117 ELMER ROAD,
ELMER,
BOGNOR REGIS,
PO22 6LH

SURFACE WATER DRAINAGE DISCHARGE OF CONDITIONS

Revision P2

Following the P1 revision of this DOC report, further minor amendments were requested regarding comments 21 and 30 from Arun District Council (which are included in Section 2.4 of this report). As such, the CIV01 and CIV02 drawings (Appendix I) have been updated.

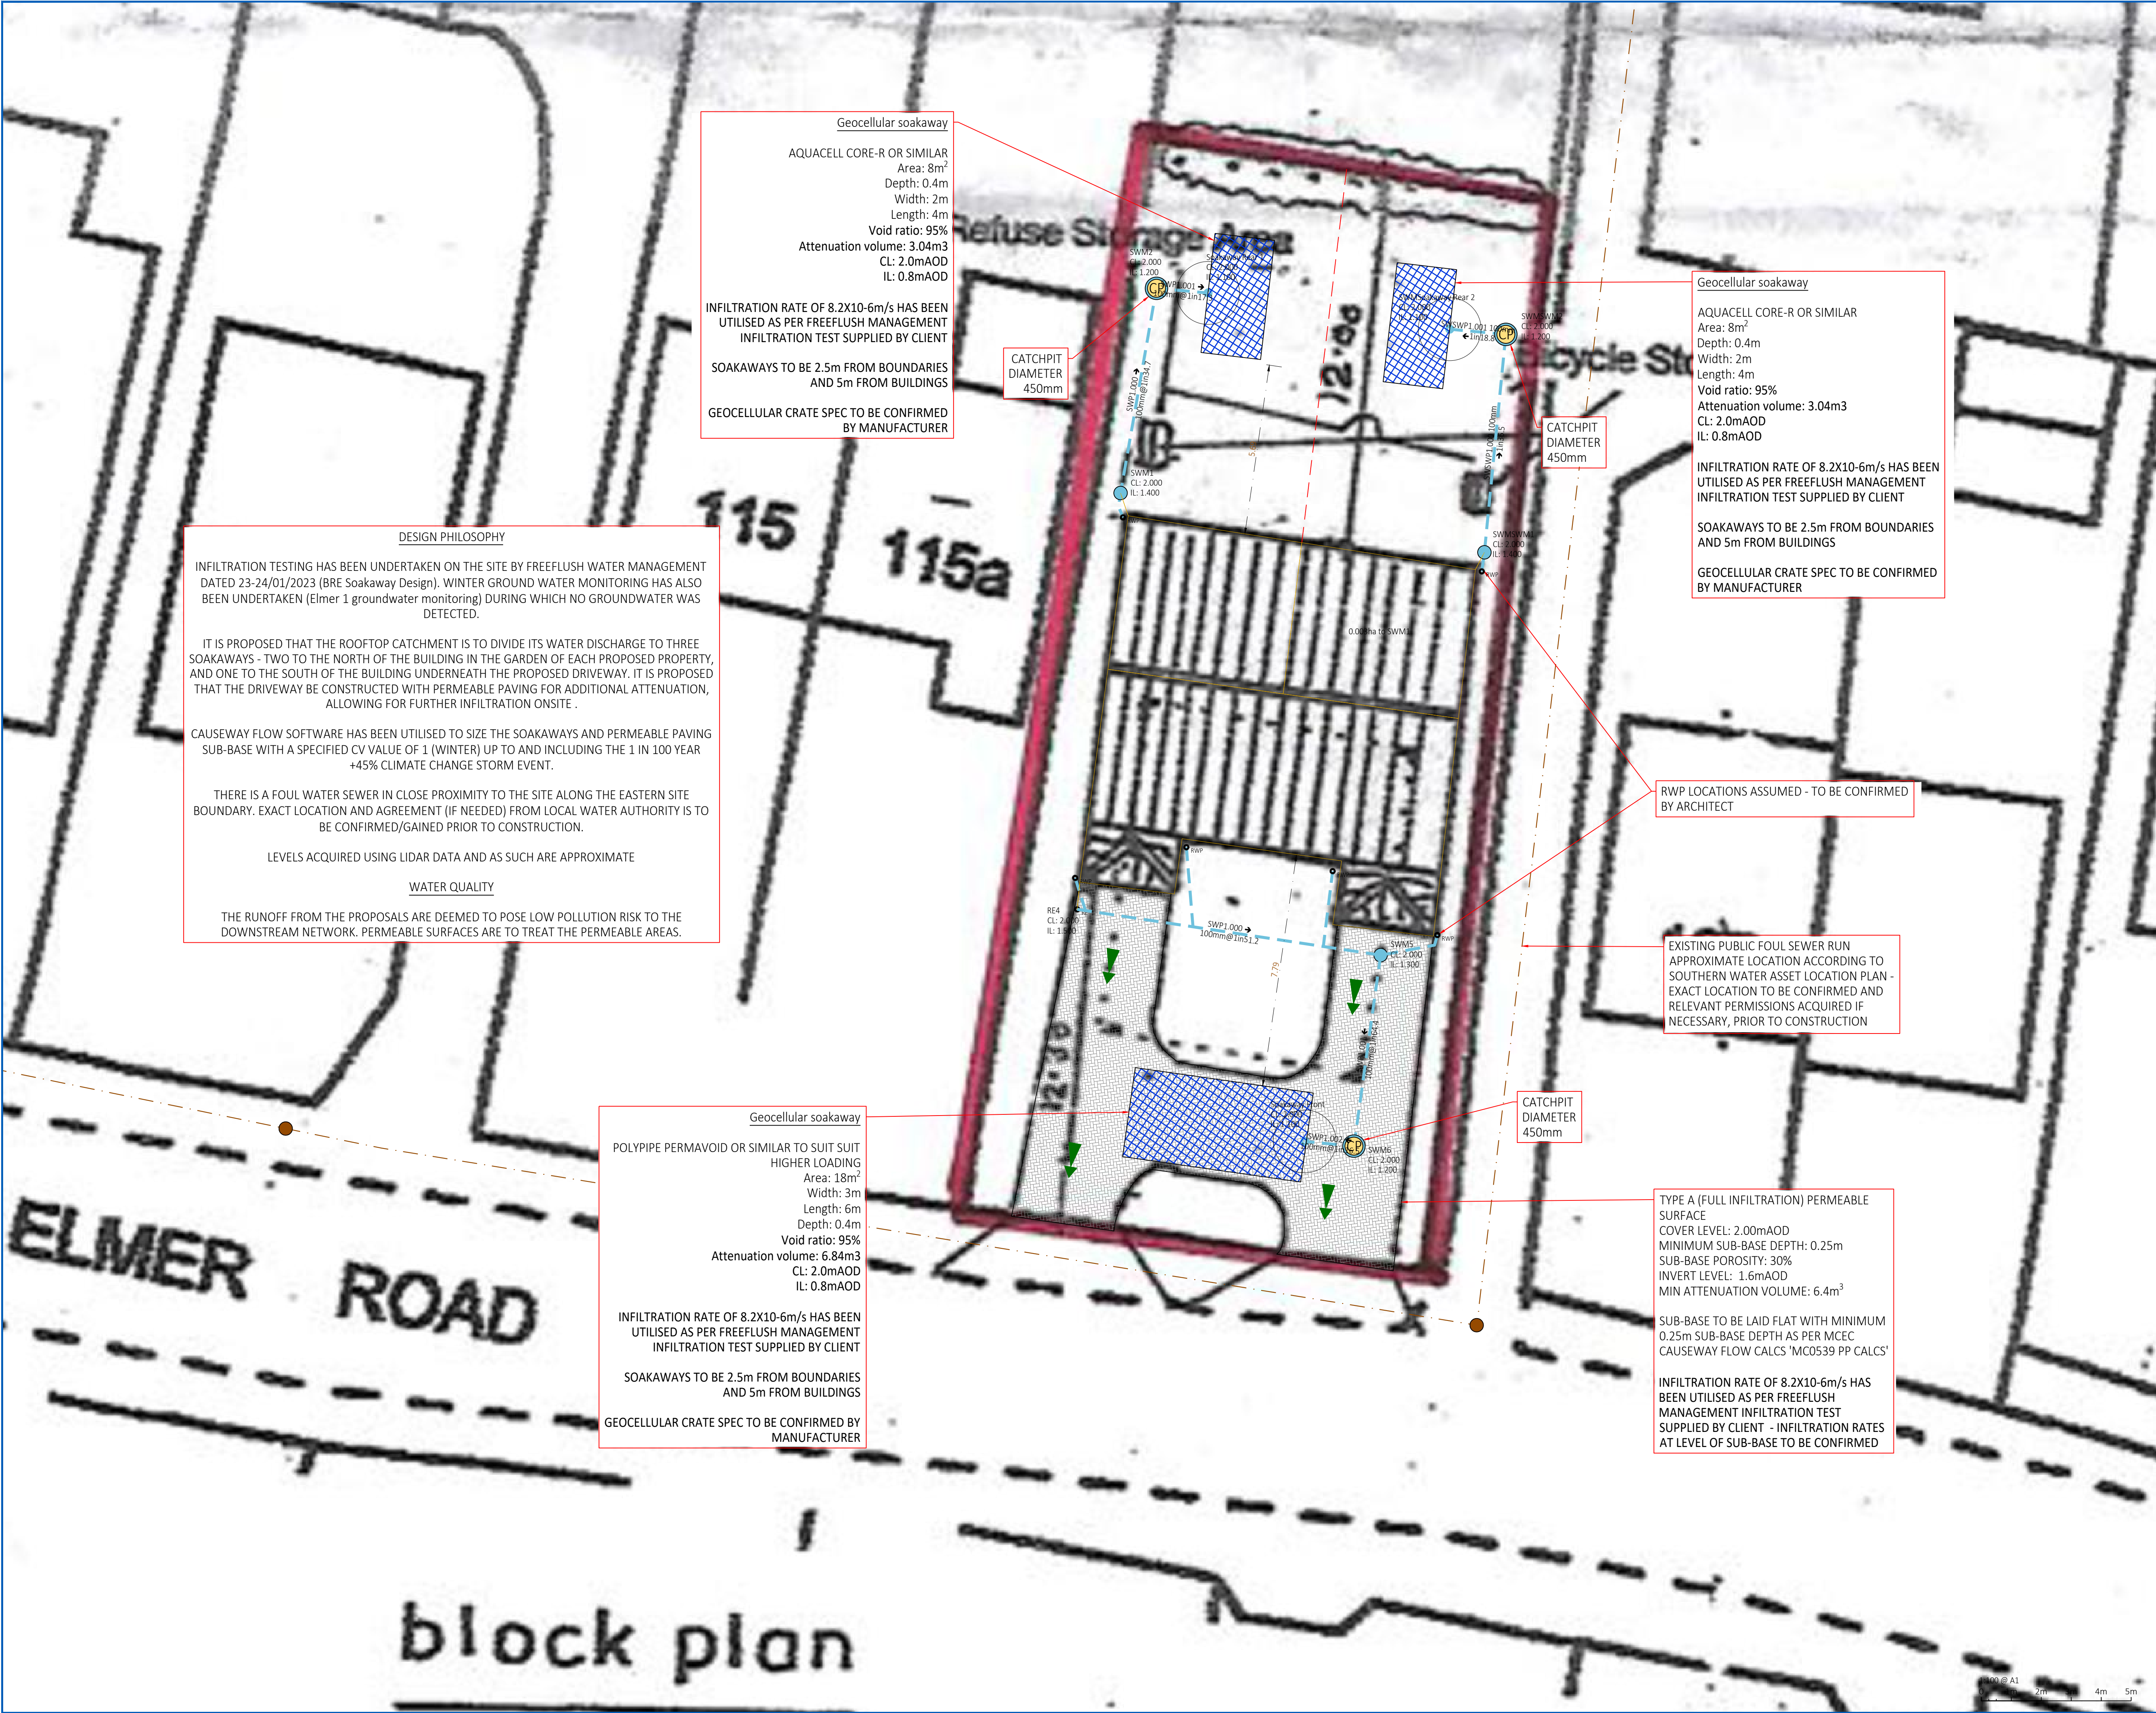
Comment Number	Drainage Condition	MCEC comment
5	<i>Please see comments 14, 17, 19, 20-23 below.</i>	See MCEC comments for 14, 17, 19 20-23 below.
6	<i>Provided – see comments 14, 15, (19), 22, (23), 26-28 below.</i>	See MCEC comments for 14, 15, 19, 22, 23, 26-28 below.
8	<i>Summer CV is 0.75, please correct to 1.</i>	Summer CV has been set to 1, and resulting changes have been made to the drainage design to account for the increase in runoff from the original CV setting. See attached CIV01 drawing for adapted drainage design, as well as Appendix II for accompanying calculations.
10	<i>Gradients provided. Pipe upstream of SWM1 does not include gradient and is likely steeper than 1 in 100 as described by the notes.</i>	Drainage design has changed, therefore rectifying the issue raised concerning pipe gradients. See attached CIV01 drawing for adapted drainage design, as well as Appendix II for accompanying calculations.

14	<i>'Notes state 'or similar'. The exact crate must be specified, or the specifications of an alternative. Is capable of withstanding vehicular loading at 1.2m depth.</i>	Crate specifications have been provided for the front and rear soakaways which reflect their structural requirements.
15	<i>Please also label the membrane below the tarmacadam on the permeable paving detail.</i>	Amended – see CIV02 for construction detail.
17	<i>Why is there no rodding eye or inspection chamber north of the proposed 117a at the junction of the RWP? Upstream of SWM1.</i>	Drainage design has changed, therefore rectifying the issue raised concerning the absence of rodding eye or inspection chamber at this location. See attached CIV01 drawing for adapted drainage design.
18	<i>The design has changed to two (rather than 4) soakaways. These are in the centre of the divided front and rear gardens. How will management and maintenance be organised between the future homeowners?</i>	Proposal has been altered to address this concern. There are now two rear soakaways – each proposed in garden of the properties, and safely positioned (at least 5m away from any building, and at least 2.5m away from any boundary). See attached CIV01 drawing for adapted drainage design.

19	<i>Please provide a plan and details showing how that the new design for the rear soakaways will not be structurally impacted by the boundary treatments – particularly in the rear gardens.</i>	Updated drawing includes an assumed boundary line and two rear soakaways rather than one combined across the two proposed properties. This indicates how the rear soakaways will not be structurally impacted by the boundary treatments. See attached CIV01 drawing for adapted drainage design.

20	<i>Suggested: include dimensions of the soakaways rather than just plan areas.</i>	Additional length and width dimensions have been included in the Soakaway notes in addition to total plan areas and depths – see attached CIV01 drawing.
21	<i>Soakaways must be set at 1.2m below ground level to accord with the infiltration testing (see point 1). Therefore, the soakaways must be set deeper.</i>	All proposed soakaways have been set at the requested depth, with drainage redesigned to account for this change. See attached CIV01 drawing for adapted drainage design, as well as Appendix II for accompanying calculations.
22	<i>Soakaway base levels appear to not be consistent between the construction details and the layout. It is assumed that the IL labelled directly next to the soakaways related to the incoming pipe invert levels. Please Clarify. It is suggested that the incoming pipe invert level, or the base of the soakaway are labelled with different notation on the layout to avoid confusion.</i>	Drawing annotations have been altered to provide clarity – see attached CIV 01 drawing.

23	<i>Suggested: A link could be provided between the permeable paving subbase with a diffuser unit connected to SWM6 so the the two systems are linked to maximise infiltration and storage. This is suggested on the basis of a lack of design infiltration rate at the proposed depth of the now formal permeable paving construction.</i> <i>If provided, please provide a construction detail drawing, to include base level of diffuser and invert level at the point of connection of the catchpit.</i>	MCEC have opposed this suggestion. The roof runoff area has been designed to run directly into the soakaways to allow for a greater than 5m proximity to the building for infiltration. Use of diffuser units would not be possible or safe to implement as infiltration would be promoted less than 5m from the building, possibly compromising its long-term structural integrity.
24	<i>Climate Change allowance for the 1% AEP event must be 45%.</i>	Climate change allowance for the 1% AEP event has been increased from 40% to 45% for drainage calculations. See Appendix II for accompanying calculations.

<i>100mm in accordance with the design.</i>	
29	<i>The design infiltration rate has been applied to the base and sides of the soakaways and permeable paving in the calculations. Please apply to the base OR the sides, not both.</i> <i>The design infiltration rate must be 0.02952m/hr or 8.2x10⁻⁶m/s.</i>	The design infiltration rate of 0.02952m/hr has been applied to only the base of each proposed soakaway, with no side infiltration used in the calculations. See Appendix II for accompanying calculations.
30	<i>Please provide construction detail for oblique pipe to pipe connections/junctions.</i>	Oblique Pipe Junction detail has been added to CIV02.
31	<i>Please illustrate exceedance flow routes.</i>	Exceedance flow routes have been illustrated on the front driveway – see attached CIV01 drawing.

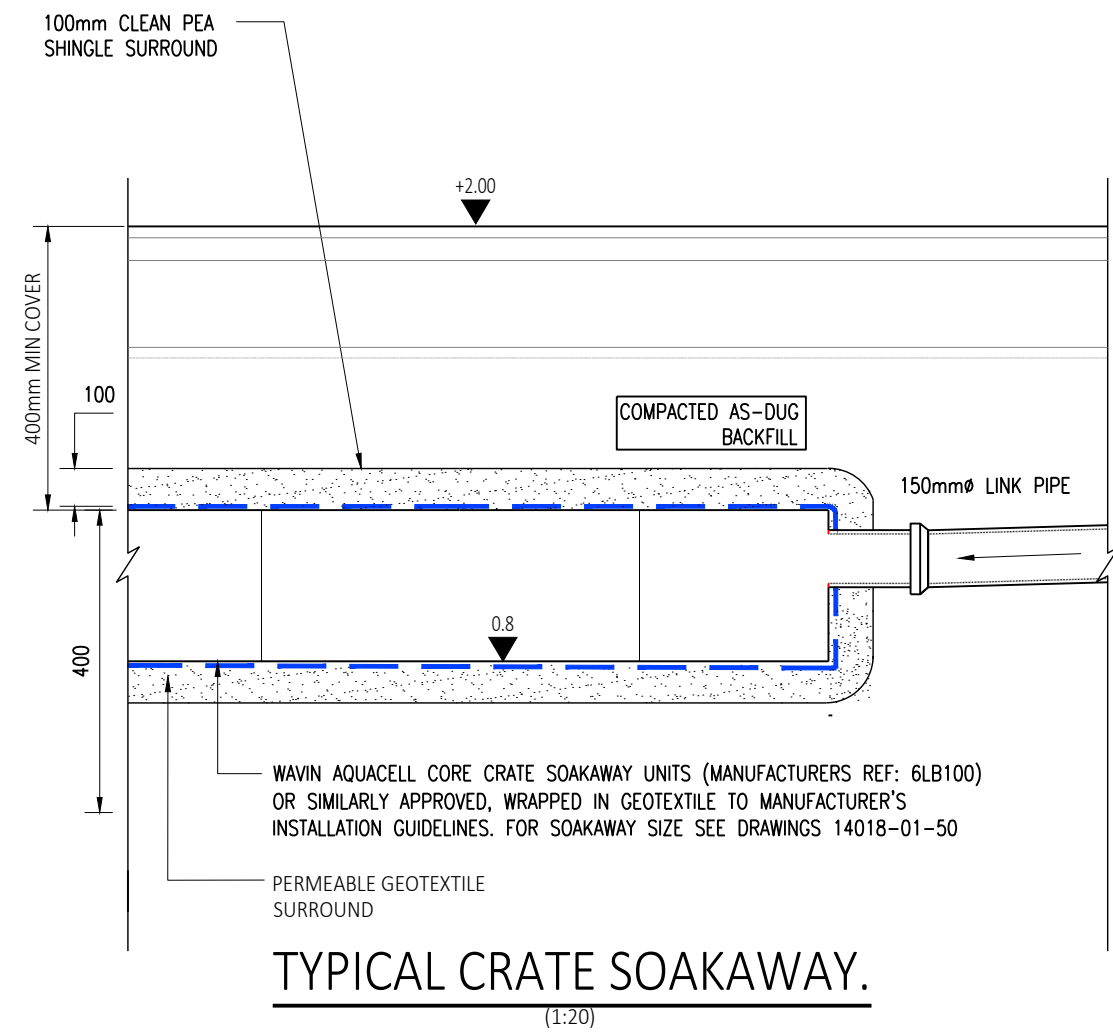
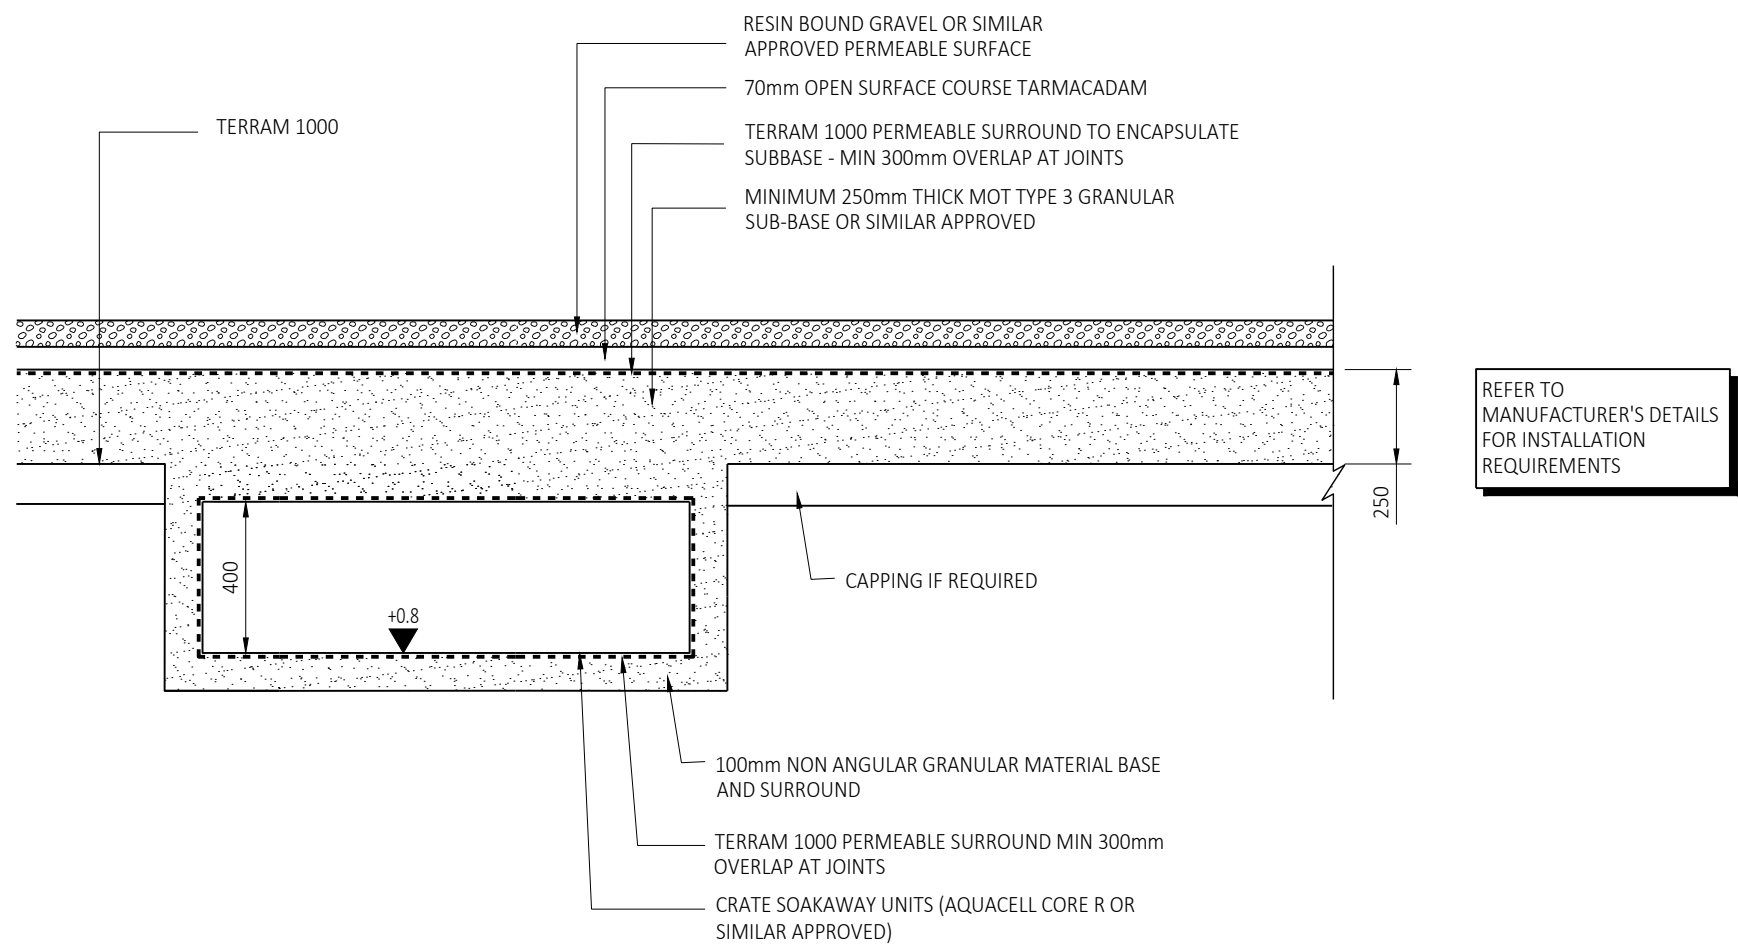
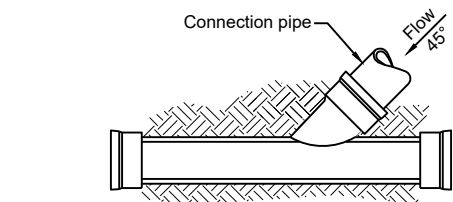
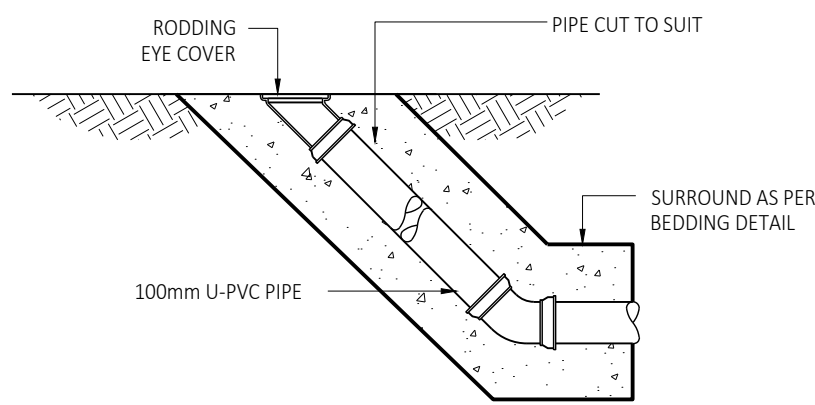
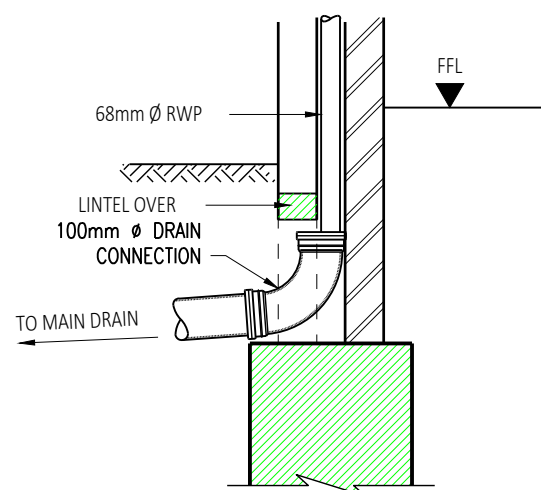
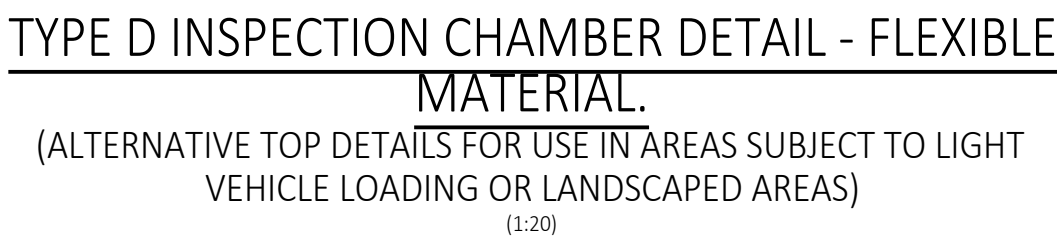
25	<i>Please provide 10%+CCA and 3.33%+CCA calculations.</i>	The 10%+CCA and 3.33%+CCA events have now been included as part of the provided calculations. See Appendix II for accompanying calculations.
26	<i>Please specify catchpit diameter.</i>	Annotations have been included in the CIV01 drawing which detail the designed catchpit diameters.
27	<i>Typical crate soakaway refers to a slotted pipe, it is not clear why. Please adjust.</i>	Typical Crate Soakaway detail in CIV02 has been amended.
28	<i>Rodding eye detail, the pipe diameter needs to be corrected to</i>	Rodding Eye Detail in CIV02 has been amended.
